Service Letter

SL02-412/NIM December 2002

Fuel Pump Top Cover L/S35MC, S46-50-60-70MC-C (Fuel pumps without VIT) Action Code: AT FIRST OPPORTUNITY

Fuel Pump Top Cover

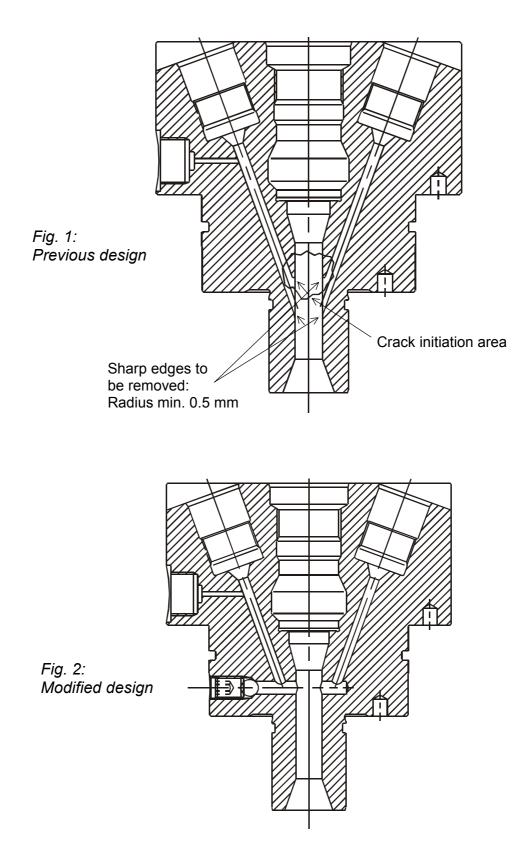
The cracks are initiated at the edge between the central bore and the inclined bores, due to the lack of the specified manual finishing of the transition edge between the central bore and the inclined bore. The crack-initiated area is shown in Fig. 1.

In order to eliminate the need for manual finishing during production, and as an alternative to this, we have introduced a modified design for future top covers. The design is shown in Fig. 2.

The modification involves the introduction of a horizontal bore connecting the vertical central bore and the inclined bores.

MAN B&W Diesel A/S Denmark CVR.No.: 39 66 13 14 We recommend checking whether the spare cover is of the original design. If this is the case, please check the transition between the vertical bore and the inclined bores. The transition area must have a radius of min. 0.5 mm. On the spare top cover, the sharp edge must be removed and a rounding of min 0.5 mm must be made.

Fuel pump suction and puncture valve combined 70MC/MC-C, 60MC/MC-C, 50MC/MC-C, 46MC/MC-C

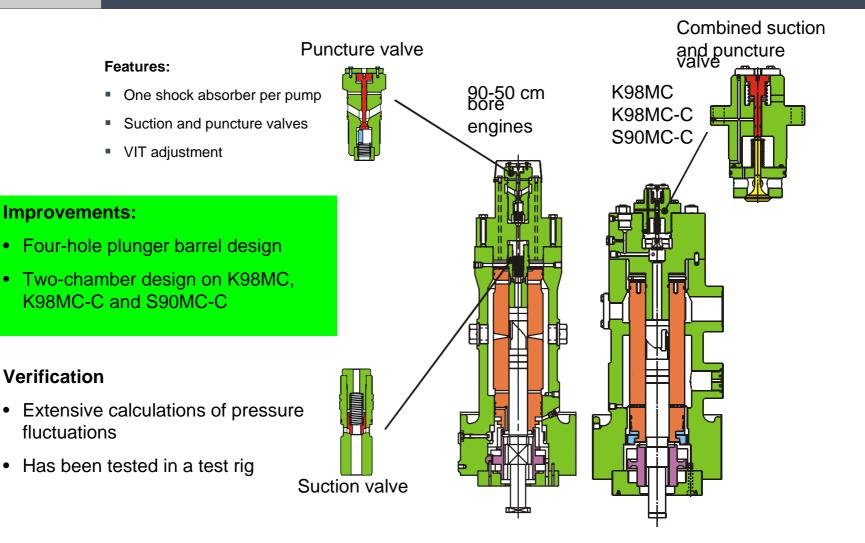
Due to cracked bellows, the design has been changed.

Unit item 2 from modified design is interchangeable with unit item 2 from previous design.

Modified according to SL97-344

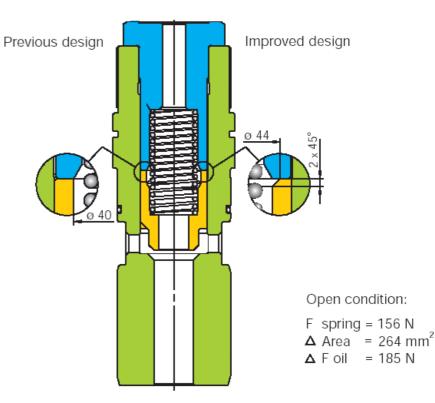
Slide without groove and sealing ring and with reduced clearance.

And where the slide again has been modified with a chamfering to ensure proper fuctioning irrespective of the fuel quality.

Always ensure to use the latest design.

Fuel Pump Suction Valve 50-90MC/MC-C Engines Sealing Ring on Slide

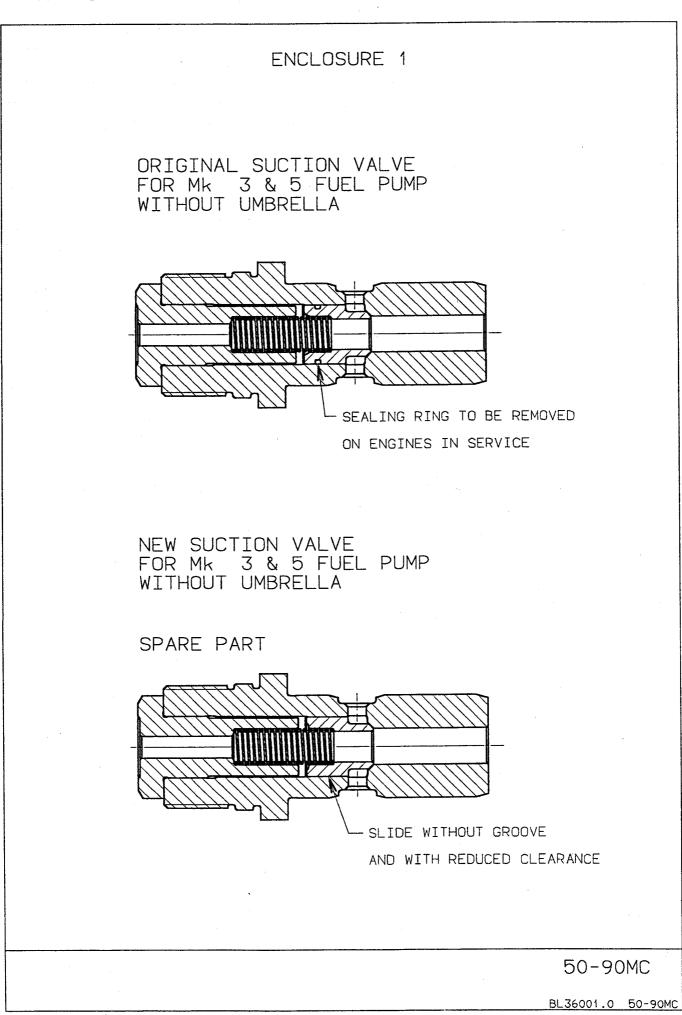
We have recently experienced incidents in which damage has occurred to the sealing ring on the fuel pump suction valve slide.

As a damaged sealing ring might lead to malfunctioning of the suction valve, we have made investigations and tests on suction valves without a sealing ring.

The results of these tests revealed that the suction valve can operate satisfactorily without the sealing ring, and we there-fore recommend that the sealing ring be removed at the next suction valve overhaul.

As for future spare parts deliveries, this suction valve slide will be specified without the sealing ring groove, and with a slightly reduced clearance between the slide and the valve housing, please see Enclosure 1.

'Umbrella' roller guide for fuel pump (K98MC-C and K98MC engines)

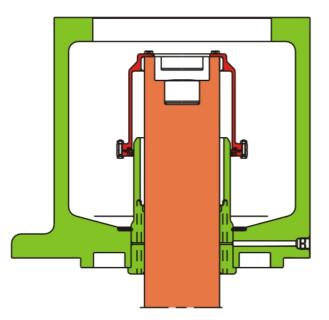
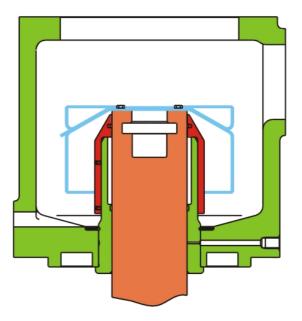
Previous design

New design

50-90 cm bore MC and MCE engines K/L45-55-67-80-80GB/GF/GFC/GFCA

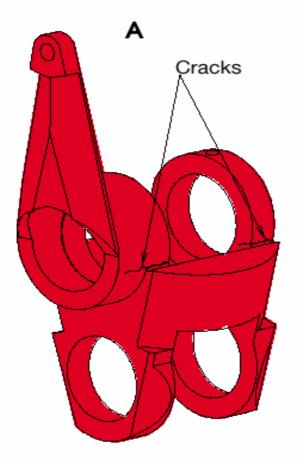
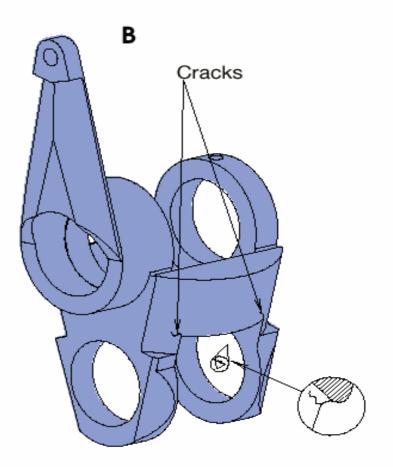
In a few cases cracks have appeared in the sealing ring groove of the housing

In certain cases the guide ring acts as a tight sealing ring because the high running temperature reduces the ring gap to almost nothing

A pressure of approx. ten times the normal working pressure is then Built up, hence causing the cracks

The problem was solved by exchanging the guide ring with a new ring with larger gap

MC Engines Reversing Link for Fuel Pump Roller Guide

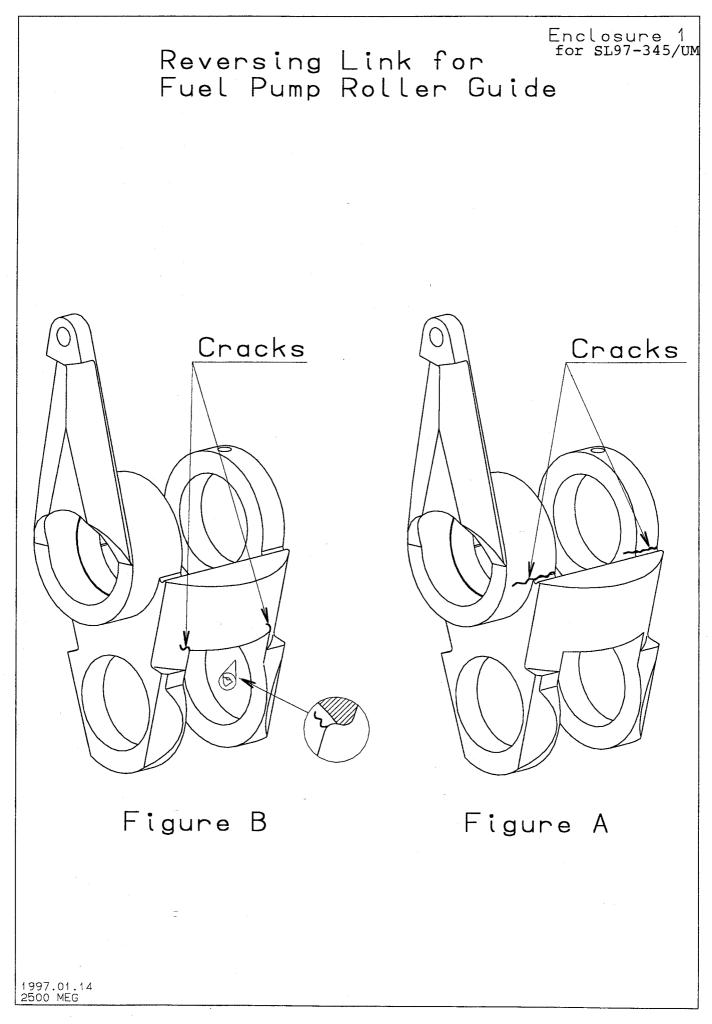
We have recently received reports on cracks in the reversing link for the fuel pump roller guide. The sketch in Enclosure 1 shows the appearance of the cracks.

The cracks as shown in Fig. B have mainly been found on the K90MC/MC-C types, Mark V or VI, and they were found after a relatively short time in service. The type of cracks indicated in Fig. A have only been reported in a few cases.

The cracks in Fig. B have primarily been located on the camshaft side and can be detected through the inspection cover in the camshaft housing. We recommend that, as a general precaution, you instruct your crews to inspect the reversing link at the first opportunity.

Even if no cracks as shown in Fig. B are detected, it is still recommended to inspect for the types of cracks shown in Fig. A, when convenient. It is necessary to pull out the roller guide in order to do this.

If cracks are detected, we ask you to make a sketch of the extent of the cracks and forward it to the engine builder or MAN B&W Diesel, Copenhagen and, at the same time, to order replacement reversing links. The new reversing links are modified with larger roundings in the relevant areas.

Checking and changing screws at fuel pump guide block

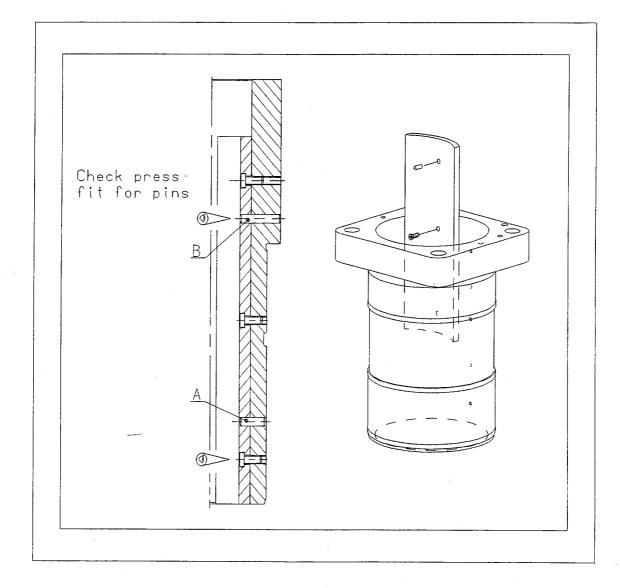
Furthermore, we want to draw your attention to another subject which should be considered in connection with the above recommended inspection of the reversing links. We have received a few reports regarding loose guide blocks for the fuel pump roller guide, see Enclosure 2. Therefore, when checking for cracks in the reversing link, we recommend that also the guide blocks are checked at the same time to see whether they are loose. This can be done when pulling the roller guide.

To improve the fixing of the guide blocks, it must be ensured that the guide pins are inserted in the holes with a tight fit. Furthermore, when new screws are mounted, these should be tightened to the torque indicated in Encl. 2, and locked with Loctite. The new screws should not be locked by caulking, as hitting the screw head improperly, could lead to a reduction of the tightening force of the screw.
